**14 South Steyne
Manly
NSW 2095**

DA – S4.55

HERITAGE IMPACT STATEMENT

Figure 1.0, Ground Floor Kitchen: Dumb waiter relocated, kitchen equipment layout changed

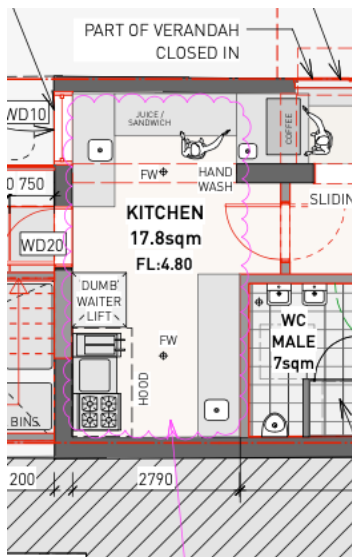
| Proposed Change | Heritage Impact |
|--|--|
| Kitchen: Dumb waiter relocated, kitchen equipment layout changed | Nil. This change is to facilitate a more efficient operation of the kitchen and has no effect on any heritage fabric. |

Figure 3.0, Ground Floor: Bar counter size increased

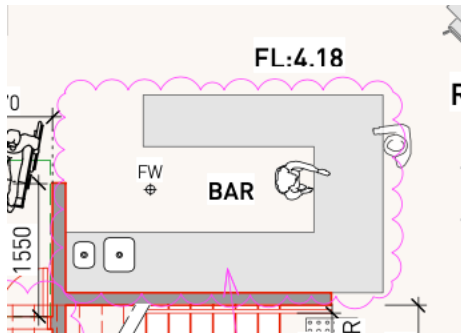
| Proposed Change | Heritage Impact |
|--|--|
| Bar counter size increased | Nil. This change has no effect on any heritage fabric. |

Figure 4.0, Ground Floor: Proposed office with staff lockers. External window W006 to remain

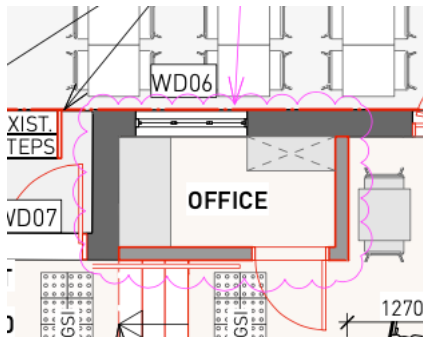
| Proposed Change | Heritage Impact |
|--|--|
| Proposed office with staff lockers. External window W006 to remain | Nil. This is a positive heritage outcome – preserving original window fenestration pattern, see images below. |

Figure 5.0, Ground Floor: Existing double folding doors WD01-05 to be replaced, like for like, with new timber framed doors. Existing highlight windows above doors to remain, repair as required and paint.

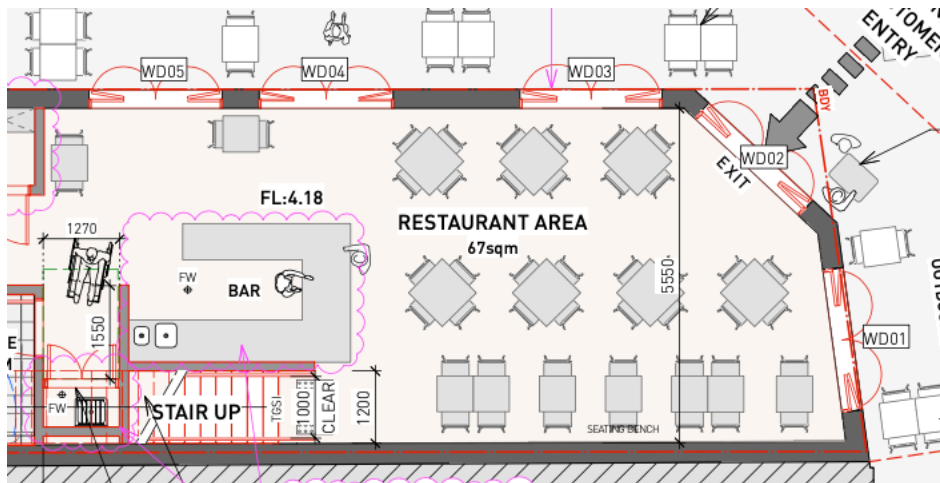
| <p>Ground Floor: Existing double folding doors WD01-05 to be replaced, like for like, with new timber framed doors. Existing highlight windows above doors to remain, repair as required and paint.</p> | <p>Nil. The double folding doors with fanlights above are integral to the character of the building. The current folding doors are not original, and replacing like for like has no effect on heritage significance. Preserving the fanlights is a positive heritage outcome, see images below.</p> |

Figure 6.0, First Floor: Existing cool room to be replaced with new cool room. Dumb waiter relocated, kitchen equipment layout changed.

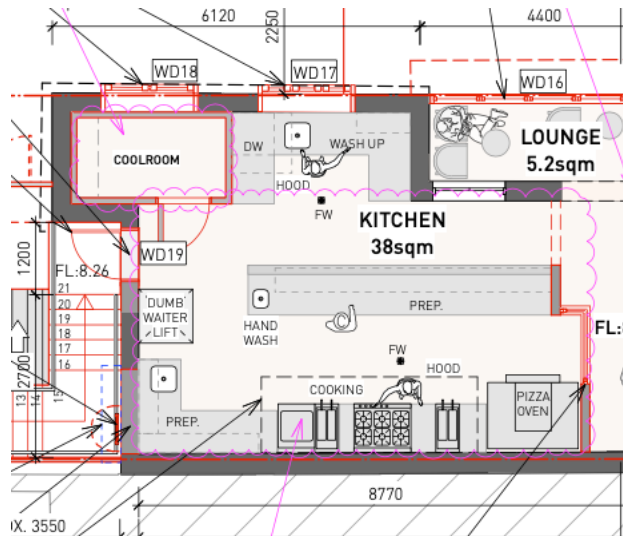
| <p>Existing cool room to be replaced with new cool room. Dumb waiter relocated, kitchen equipment layout changed.</p> | <p>Nil. This change is to facilitate a more efficient operation of the kitchen and has no effect on any heritage fabric.</p> |

Figure 7.0, First Floor: Existing internal double doors to be removed to lounge area.

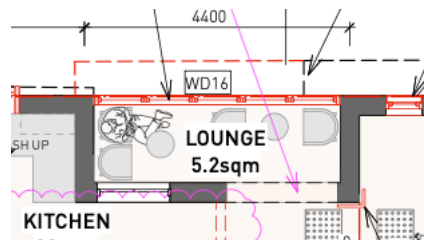
| <p>Existing internal double doors to be removed to lounge area.</p> | <p>Nil. Minor change.</p> |

Figure 8.0, First Floor: Fixed bar seating replaced with tables and chairs

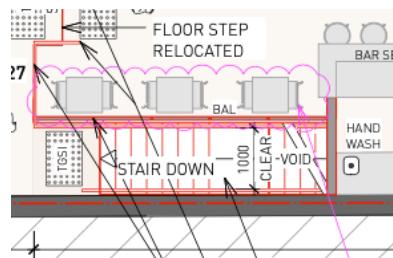
| <p>Fixed bar seating replaced with tables and chairs</p> | <p>Nil. Minor change.</p> |

Figure 9.0, Roof Plan: Mechanical ventilation equipment revised to suit kitchen exhausts – to mechanical engineering specifications. All behind acoustic screening.

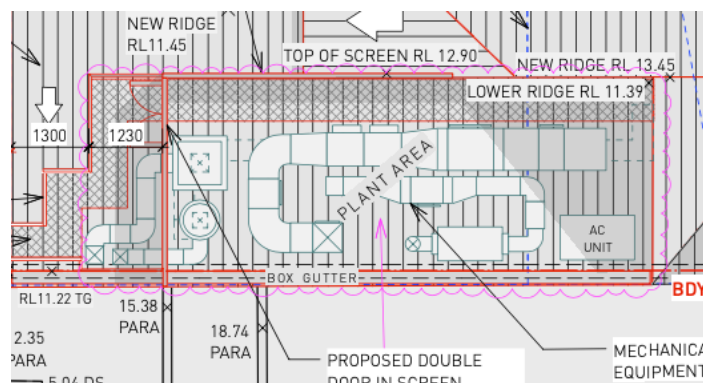
| <p>Mechanical ventilation equipment revised to suit kitchen exhausts – to mechanical engineering specifications. All behind acoustic screening.</p> | <p>Nil. Minor change. Will not affect views to the building.</p> |

Figure 10.0, Victoria Parade Elevation:

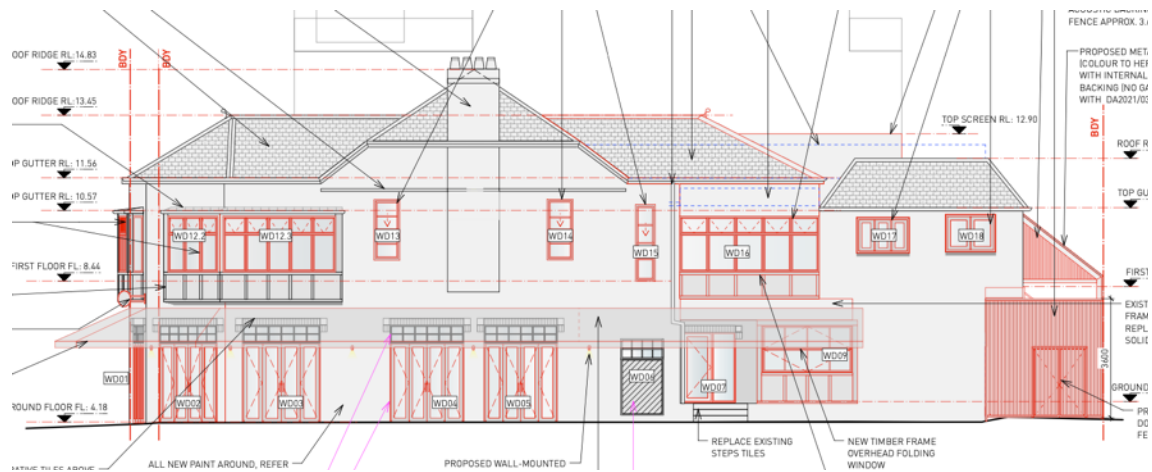
Existing double folding doors WD01-05 to be replaced, like for like, with new timber framed doors. Existing highlight windows above doors to remain, repair as required and paint. Existing timber panel and fixed window to remain, paint finish.

Figure 11.0, South Steyne Elevation

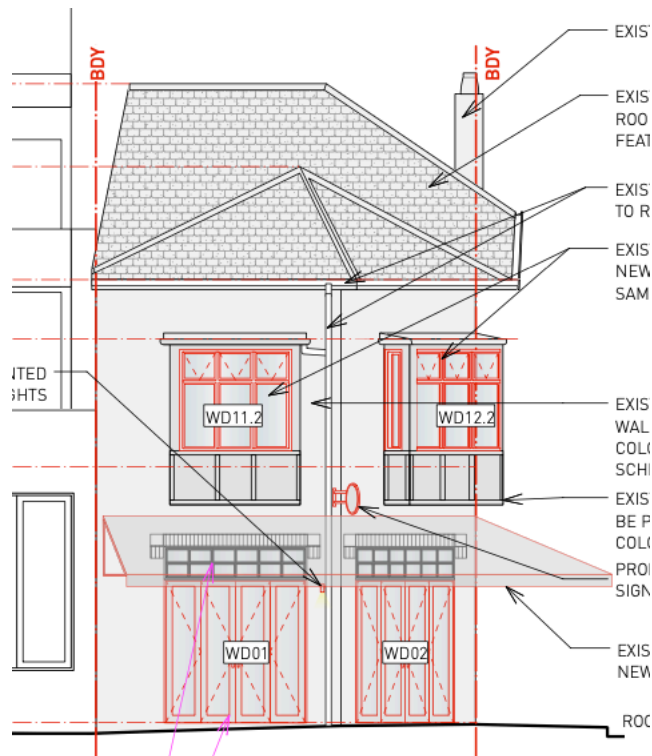
Existing double folding doors WD01-05 to be replaced, like for like, with new timber framed doors. Existing highlight windows above doors to remain, repair as required and paint.

Figure 12.0, South-West Façade: New fresh air intake louvre grilles to mechanical engineering details.

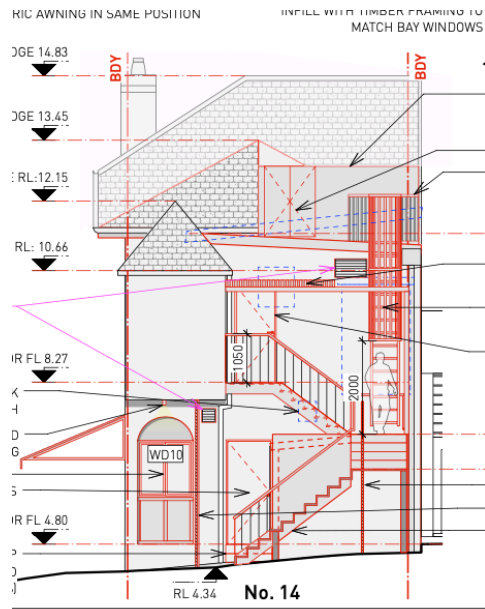
| <p>South-West Façade: New fresh air intake louvre grilles to mechanical engineering details.</p> | <p>Nil. Minor change, see images below.</p> |
